## **Access Compliance Report Public Rights-of-Way** (Curb Ramps)

Intersection ID: 23735 Main Street: CARMEL RD Cross Street: ROTUNDA\_RD Location: NE ADA ID: 2F3156649D70 Ramp Type: Perp Initial Pass/Fail: Fail **Overall Compliance: No** Severity Score: 21.25

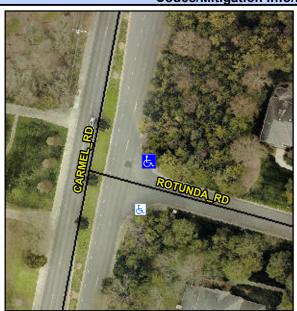
**ROTUNDA RD** Street 1 Name Stop Condition-Street 2 StopSign Street 2 Name N/A Stop Condition-Street 1 N/A Possible Solutions: Remove & Replace Entire Ramp. Surveyor Notes: N/A PROW/ADA: R304.5.1, R304.2.2

Field Measurements/Component Compliance						
Compliance Description		Data	Compl	iance	Description	Data
N/A	Ramp Length (in)	59.0	No	Ram	Slope (%)	8.9
No	Ramp Width (in)	41.0	Yes	Ramp	XSlope (%)	0.8
N/A	Flare Type LT	N/A	N/A	Flare	Type RT	N/A
N/A	Flare Slope LT (%)	N/A	N/A	Flare	Slope RT (%)	N/A
N/A	Flare Traversable LT?	N/A	N/A	Flare	Traversable RT?	N/A
N/A	Landing Length (in)	N/A	N/A	DWS	Provided?	N/A
N/A	Landing Width (in)	N/A	N/A	DWS	Contrast?	N/A
N/A	Landing Slope (%)	N/A	N/A	DWS	Length (in)	N/A
N/A	Landing X Slope (%)	N/A	N/A	DWS	Full Width?	N/A
N/A	Landing Curb? (Y/N)	N/A	N/A	DWS	Offset (in)	N/A
N/A	Shared Landing?	N/A				
N/A	Gutter Ponding?	N/A	N/A	Gutte	er Slope (%)	N/A
N/A	Gutter Lip Ht (in)	N/A	N/A	Gutte	er X Slope (%)	N/A
N/A	Painted X Walk1?	No	N/A	Paint	ed X Walk2?	N/A
	X Walk 1 Direction	To S		X Wa	lk 2 Direction	N/A
N/A	X Walk 1 Width (in)	N/A	N/A	X Wa	lk 2 Width (in)	N/A
	X Walk 1 Slope (%)	0.1		X Wa	lk 2 Slope (%)	N/A
